DESIGN RF	DRAWN BY RF	DART AEROSPACE LTD HAWKESBURY, ONTARIO, CANADA	
CHECKED 	APPROVED 	DRAWING NO. DSI 9306	REV. A SHEET 1 OF 2
DATE 05.06.27		TITLE D412-705-015 INSTALL MOD	SCALE NTS
A	05.06.27	NEW ISSUE

DART SERVICE INSTRUCTION

TO AMEND INSTALLATION INSTRUCTIONS IIN-D412-705 REV. A OR B

TO MAKE DART D412-705-015 DRIVE SHAFT TUNNEL MODIFICATION KIT COMPATIBLE WITH BELL P/N 212-061-903-177/-199 UPPER WEB ASS'Y, MODIFY THE INSTALLATION PROCEDURE AS SHOWN BELOW:

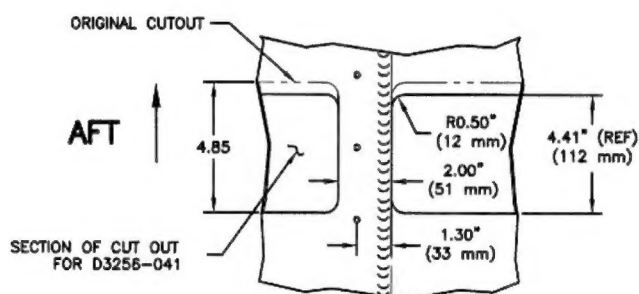
- 1) Remove P/N 212-061-903-177/-199 Drive Shaft Tunnel (Centerline Firewall) I.A.W. BHT-212 (412)-MM.
- 2) Position D3256-041 Access Panel Assembly inside Drive Shaft Tunnel as shown in Figure 1, with Tang facing aft in the bottom of the tunnel, ensuring that the panel follows the contours of the tunnel. The Aft edge of the untrimmed D3256-041 Access Panel should be 10.5" (266 mm) from the Aft end of the Drive Shaft Tunnel, or 9.88" (251 mm) from the Tang to the Aft edge. Mark the Drive Shaft Tunnel with the outline of the untrimmed Access Panel.

DETAIL A
VIEW FROM BOTTOM

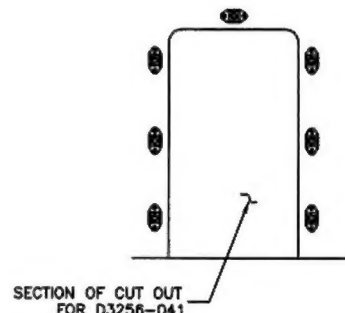
- 7) Cut out two rectangular sections of the P/N 212-061-903-177/-199 Drive Shaft Tunnel, as shown in Figure 1, Detail A. **Note: No part of P/N 212-061-903-009 Cover Assembly is Cut.** Leave the center bottom section of the P/N 212-061-903-177/-199 Tunnel as shown in Detail A. Ensure cut out will leave a minimum edge distance of 0.30" (7.6 mm) from center of each hole to cut edge. Deburr the cut out. Dimple remaining rivet holes not used in step 5. Install MS20427M3 rivets where center bottom section of the P/N 212-061-903-177/-199 Tunnel attaches to the P/N 212-061-903-009 Cover Assembly.

DETAIL B
SIDE VIEW

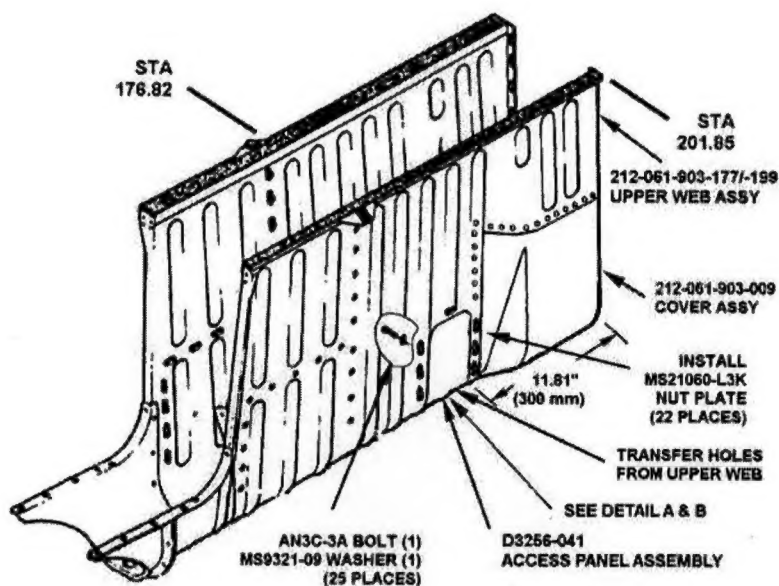
- 8) Upsize the holes used for step 5 to $\varnothing 0.204"$ ($\varnothing 5.18$ mm) on Access Panel and P/N 212-061-903-009 Cover Assembly for clearance size on AN3 bolts. Install MS21060-L3K nut plates (22 places) using MS20427M3-3 rivets (use #40 drill 44 places) as shown in Figure 1.
- 9) Install D3256-041 Access Panel Assembly into Drive Shaft Tunnel using AN3C bolts provided. Use AN3C-3A bolts on the sidewalls and AN3C-4A bolts (2 places) on the bottom center locations. Ensure good fit between the Access Panel Assembly and the Drive Shaft Tunnel. Torque bolts to a maximum torque 25 in-lb (3 Nm).
- 10) Re-install modified Drive Shaft Tunnel I.A.W. B.H.T.-212 (412)-MM
